LLOYD'S REGISTER OF SHIPPING

Ship's Name M.V. MELTEM II.Official No. -

Memorandum of alterations reported since ship was surveyed for assignment of Load Lines in Alterations

converting forward hold for carriage of Aviation Spirit or Petroleum in Bulk.

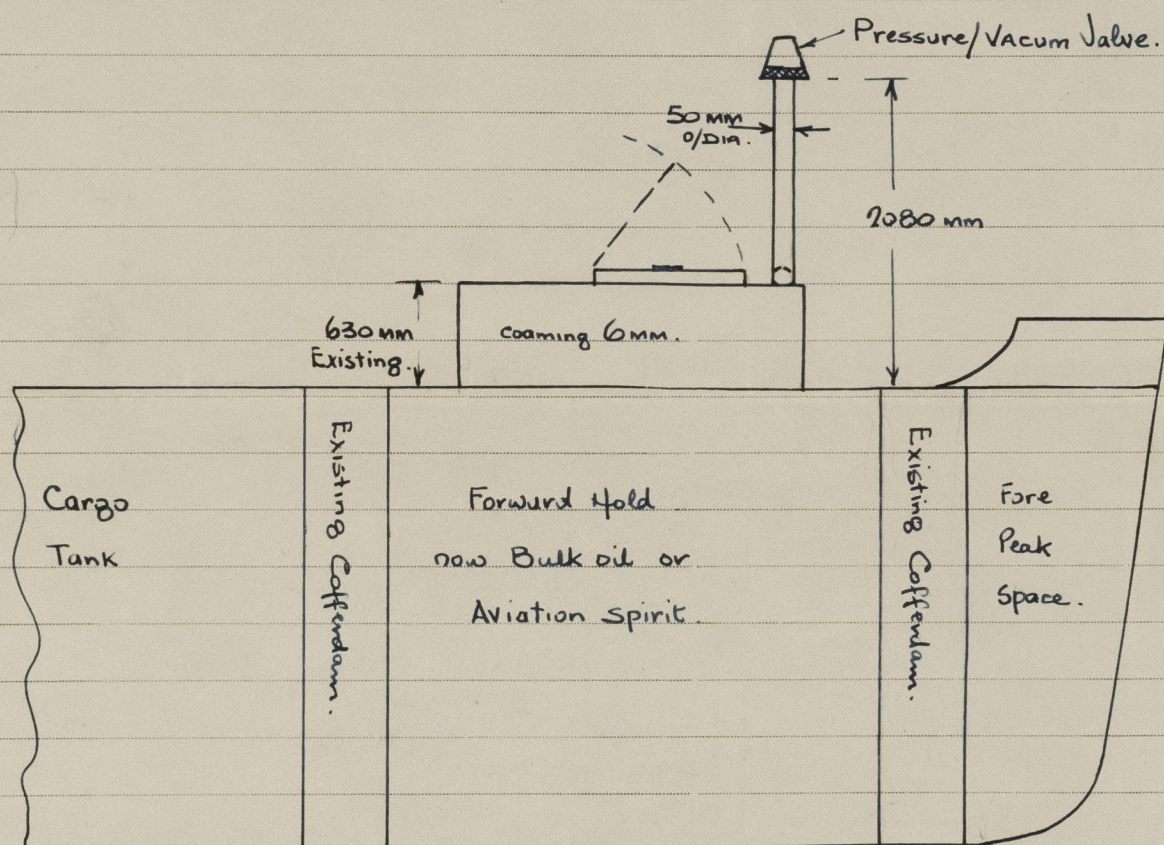
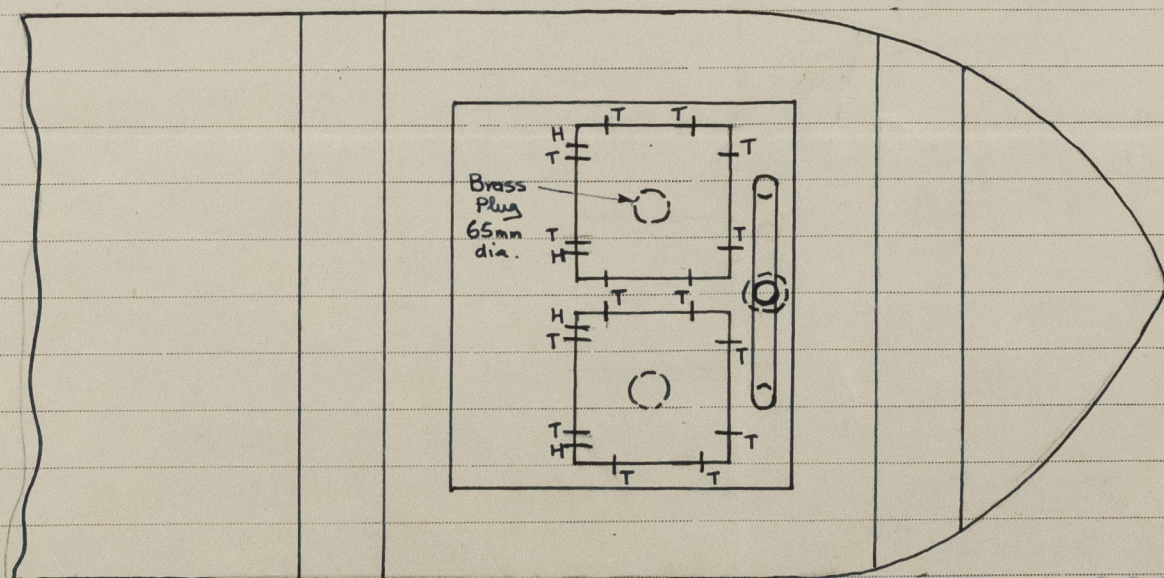
(1) Existing hold hatch cover removed and opening efficiently plated-over, access openings (1P & 1S) cut in and efficient oil tight hatch covers fitted as per existing main cargo oil tank covers.

(2) Air pipe fitted from each tank leading to a combined outlet pipe above hatch

(3) After pump room casing removed and opening efficiently plated-over gauges incorporated on air pipes and bannes covers supplied.

Hatch opening (1P & 1S) 600 x 600 x 50 mm high coaming.

Cover and coaming 6mm Thick, toggles spaced 140mm from ends

Packing on underside of cover of the greasy hemp type.
